RESPONSE TO REQUEST FOR ADDITIONAL INFORMATION

APR1400 Design Certification

Docket No. 52-046

RAI No.: 68-7892
SRP Section: 07.07 - Control Systems Not Required for Safety
Application Section: 7.7
Date of RAI Issue: 07/10/2015

Figure 7.7-5-1 Internal network architectural layout of PCS and other non-safety I&C systems

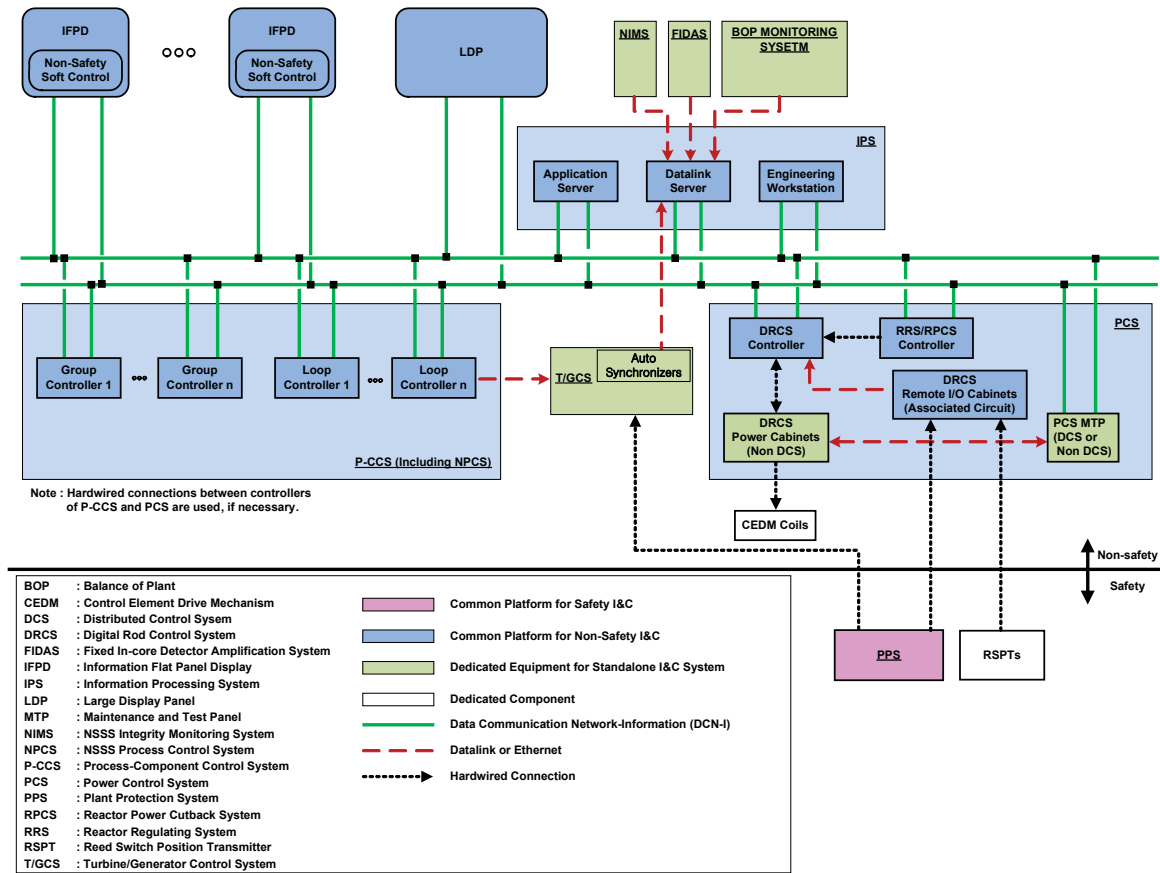
Clarify the network architectural arrangements and interfaces for the individual non-safety I&C systems, with specific attention to those cited in the failure boundary portion of Figure 4.1-1 in Technical Report APR1400-Z-J-NR-14012-P, Rev.0, "Control System CCF Analysis Technical Report."

1. Are there figures illustrating the internal network architectural layout of specific non-safety I&C systems such as the power control system (PCS), as it is described in APR1400 FSAR, Tier 2, Section 7.7? This is critical as the PCS system contains multiple subsystems such as the reactor regulating system (RRS) and the digital rod control system (DRCS).
2. Describe the interface, along with communication type and logic, facilitating the turbine trip function from a reactor trip signal. APR1400 FSAR, Tier 2, Section 10.2.2.3.3, describes the Turbine Generator Control system as a 2-out-of-3 logic system but the Plant Protection System is a 2-out-of-4 logic system.
3. In Figure 4.1-2, "Control System Overview," of Technical Report APR1400-Z-J-NR-14012-P, the acronym, "RRS" (Reactor Regulating System?) is not defined in the drawing key.

The internal network architecture of the PCS and other communication architecture mentioned in the above description are shown in Figure 7.7-5-1 for information. The PCS MTP can use the common platform for non-safety I&C or dedicated equipment. If dedicated equipment is used, a dedicated gateway will be applied to interface with the DCN-I network. The Control groups of the PCS and the P-CCS are described in Table 4.5-2 in Technical Report APR1400-Z-J-NR-14012-P. Each control group function of the P-CCS in Table 4.5-2 is assigned to at least one group controller or one loop controller.
